**City of Lake Elmo  
Planning Commission Meeting  
Minutes of June 10, 2019**

## STAFF REPORT

**TO:** Planning Commission  
**FROM:** Ken Roberts, Planning Director  
**AGENDA ITEM:** **Conditional Use Permit – Carmelite Hermitage of the Blessed Virgin Mary**  
**REVIEWED BY:** Ben Prchal, City Planner

To: Ken Roberts, Planning Director Re: Carmelite Site Improvements  
Cc: Chad Isakson, Assistant City Engineer Engineering Site Plan Review  
From: Jack Griffin, P.E., City Engineer

X-02.5 GUTTER ELEVATION

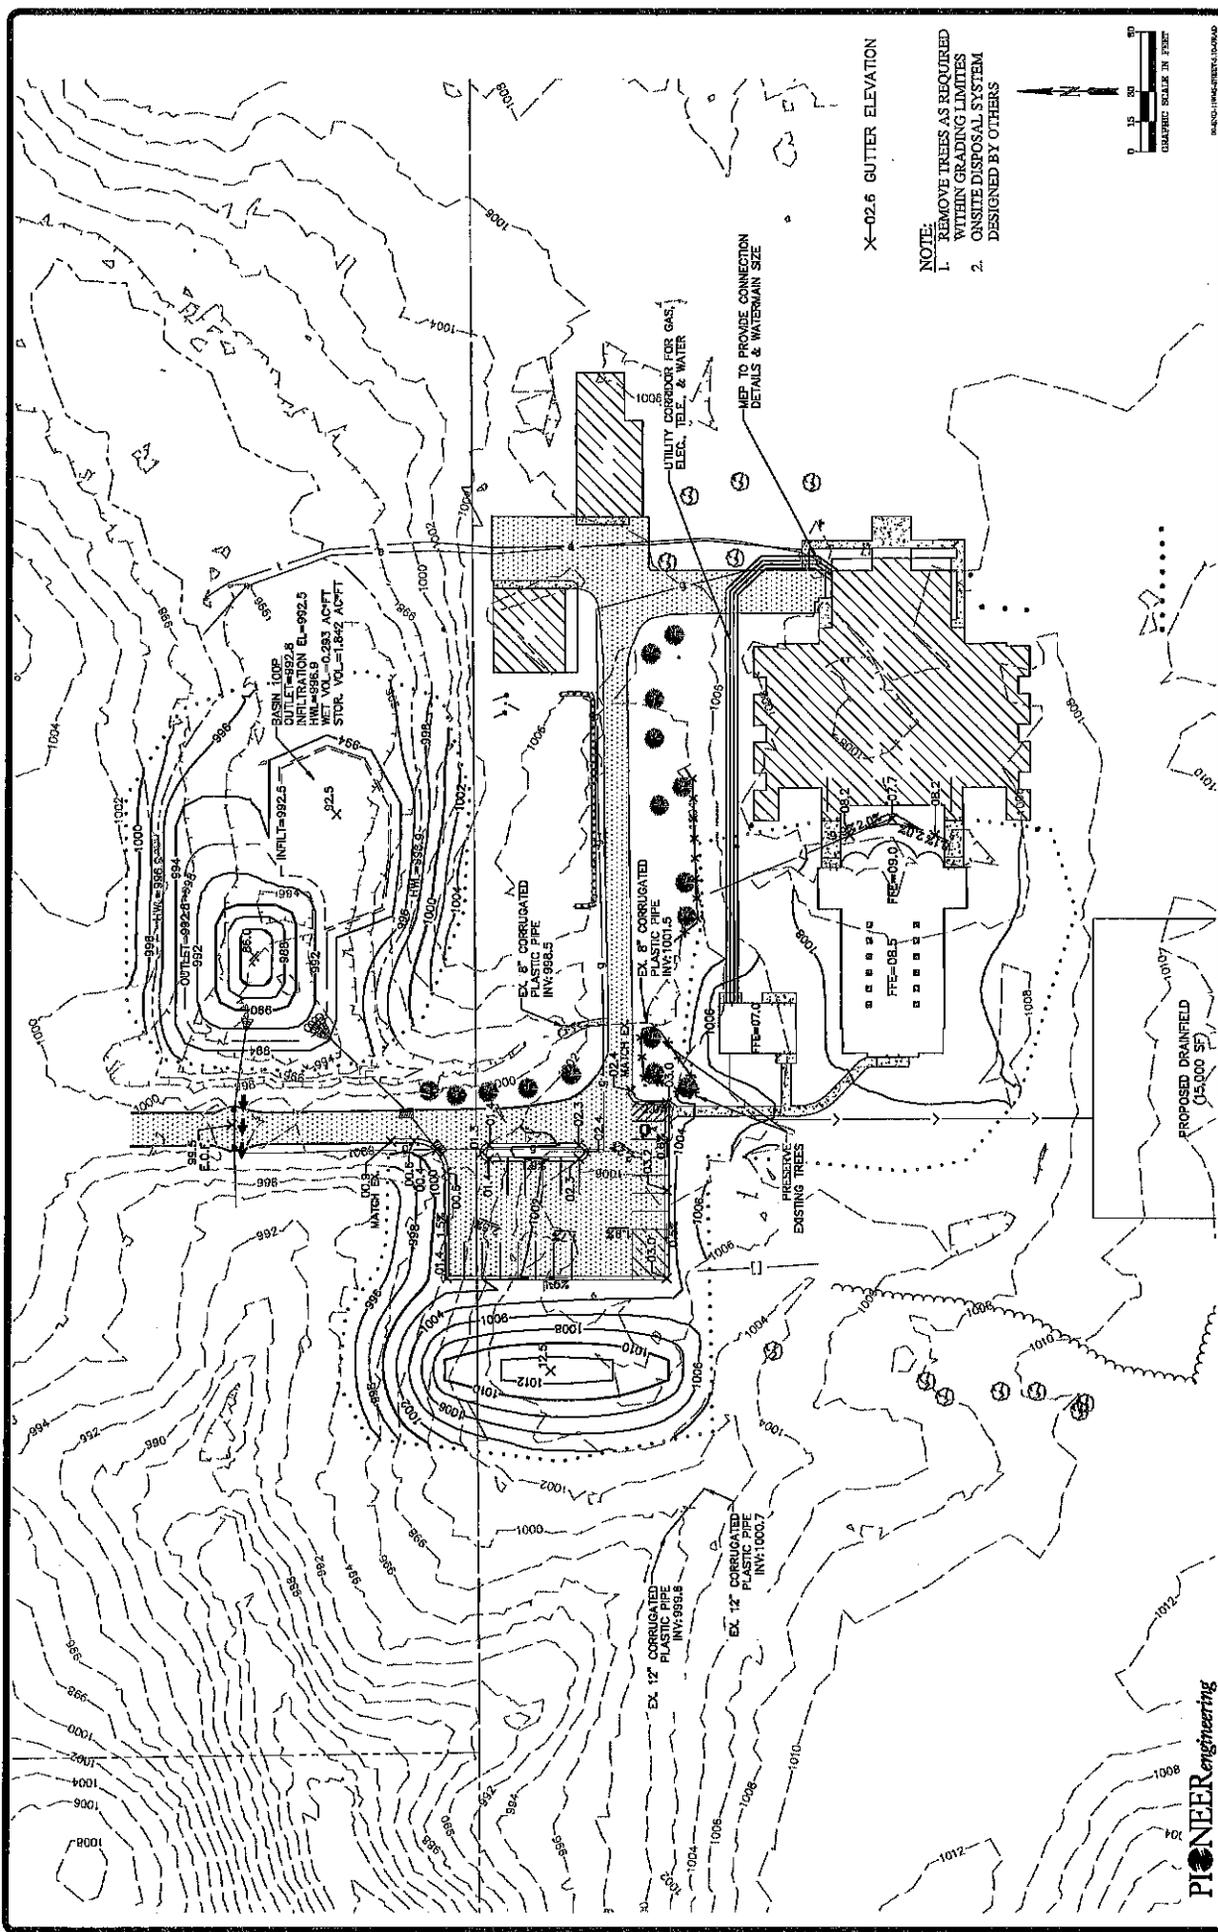
- Sheet 4.10. The sanitary sewer and water services must be identified as to size and material. A plan note should be added to indicate the sanitary sewer and water service lines per state plumbing code requirements.

- Sheet 5.10. Revise grading plan to revise storm water BMP site to meet City of Lake Elmo and MN Storm Water Manual standards and as follows:
  - Provide 10:1 aquatic bench and 10:1 maintenance bench around retention BMP.

- Provide 3:1 length to width ratio for retention basin.
  - Provide defined rip rap overflow location between retention basin and infiltration basin and define overflow spot elevation.

- Provide retention basin NWL and ensure minimum 3-feet depth. Show NWL level contour on the plan sheet.
  - Provide 100-year HWL contour for the 996.9 HWL. The 100-year HWL of 996.9 is not shown consistent between Sheets 5.10 and 5.30. Revise plans and use spot elevations has required to demonstrate extent of 100-year HWL.

- Sheet 5.10 Provide drainage and utility easement over storm water BMP including the 100-year HWL and pond maintenance access road and access bench. Access road grade must be less than or equal to 10% to the maintenance bench.

- Sheet 5.10. Remove plan note that states “Remove Trees as required within grading limits”. All trees to be removed must be surveyed and shown on the plans. Tree removal may be subject to replacement per City ordinances.

- Sheet 5.20. The rock construction entrance must be positioned for all grading activity on site; not just for basin 100P.
- The site plans must be updated to show the proposed on-site SSTS design. The Septic System Plan prepared by Steinbrecher Companies is not consistent with the site improvements plans.
